### **3. Utility Easement Vacation; KPB File 2023-132V**

**Request: Vacates the entire utility easement granted by Plat KN 2022-031 crossing diagonally through Lot 4 & vacates the easternmost portion of the easement granted by Plat KN 2022-031 excluding the westerly 22.27 section in Lot 1B**

**KPB 2023-132V**

**STAFF REPORT**

**PACE'S PLEASANT HAVEN 2022 REPLAT**

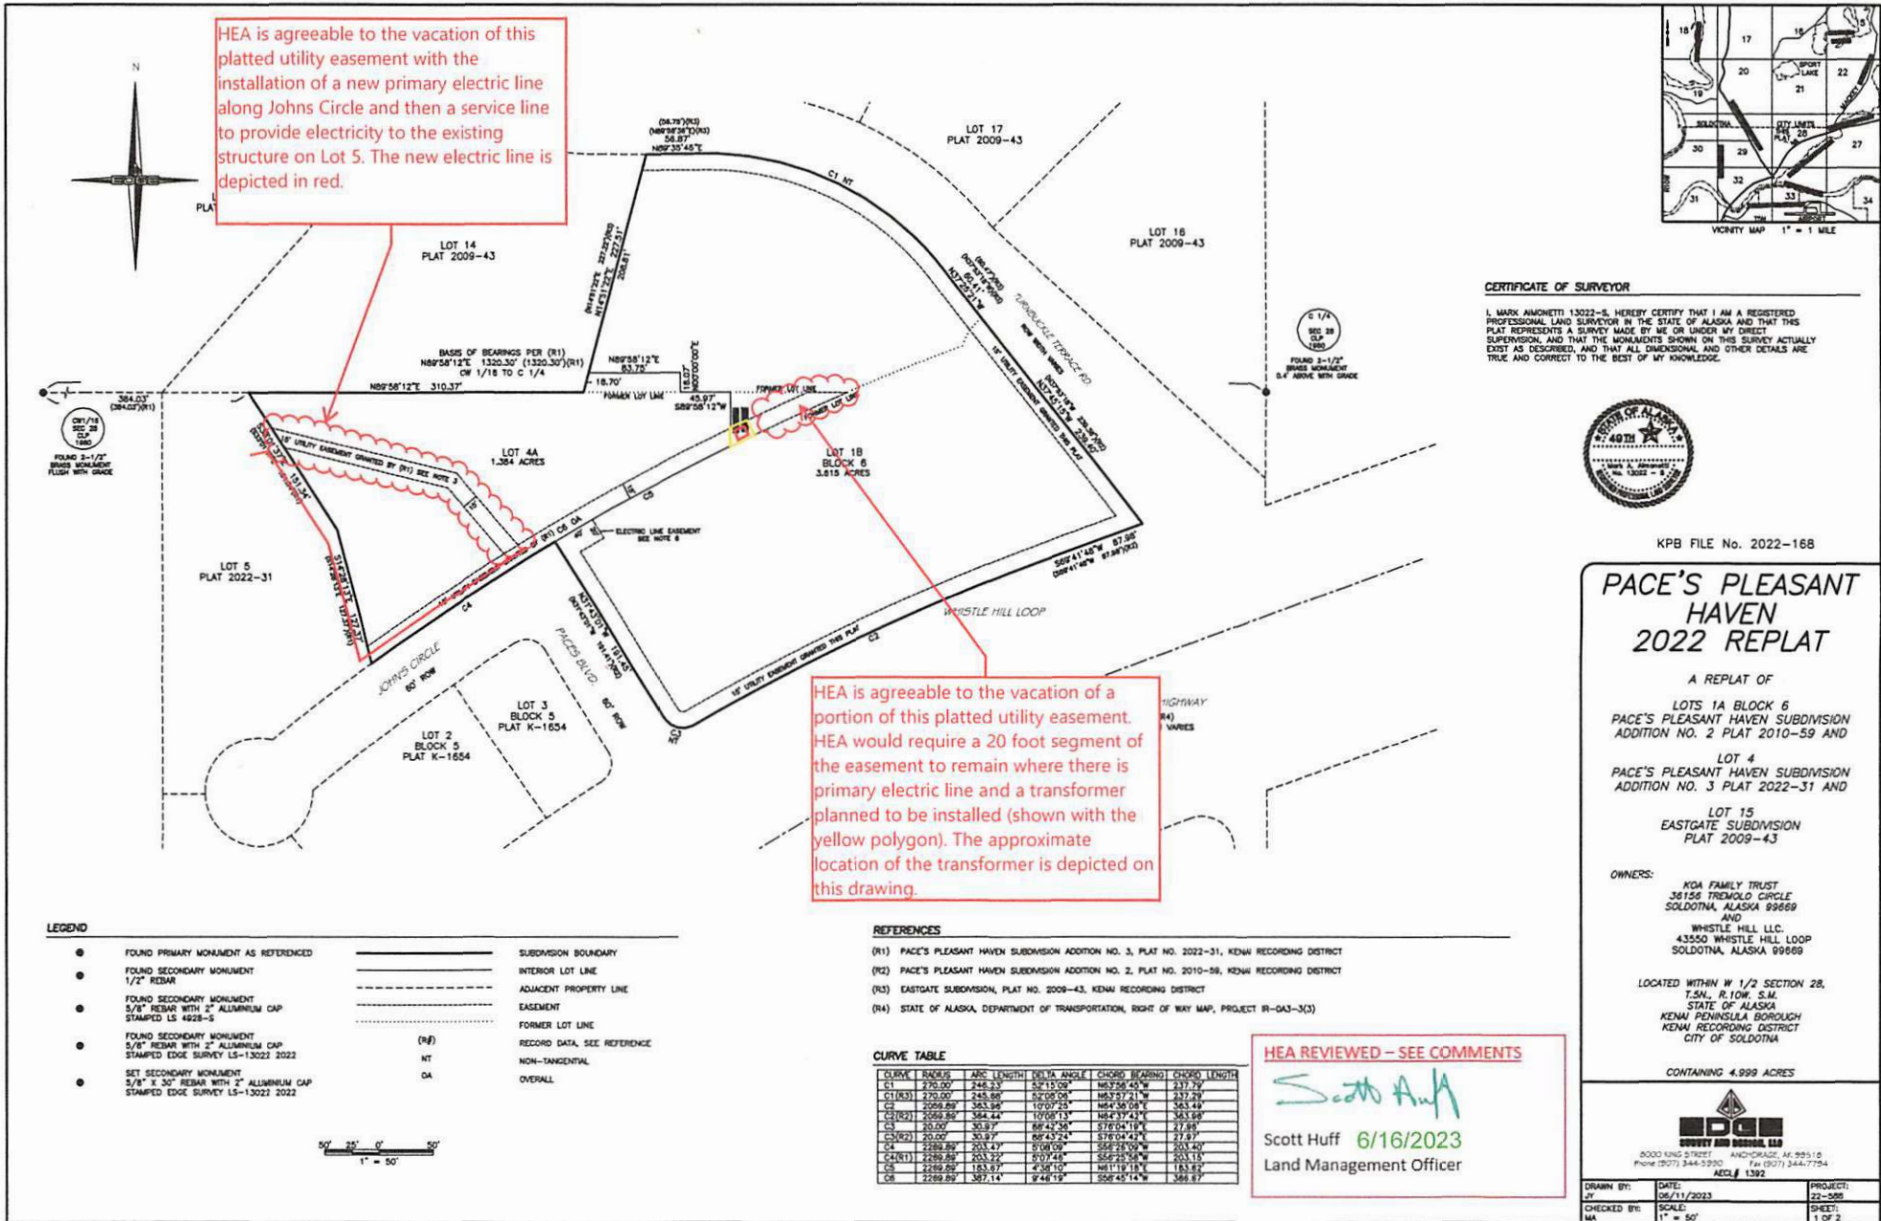
HEA is agreeable to the vacation of this platted utility easement with the installation of a new primary electric line along Johns Circle and then a service line to provide electricity to the existing structure on Lot 5. The new electric line is depicted in red.

HEA is agreeable to the vacation of a portion of this platted utility easement. HEA would require a 20 foot segment of the easement to remain where there is primary electric line and a transformer planned to be installed (shown with the yellow polygon). The approximate location of the transformer is depicted on this drawing.

HEA REVIEWED - SEE COMMENTS  
*Scott Huff*  
 Scott Huff 6/16/2023  
 Land Management Officer
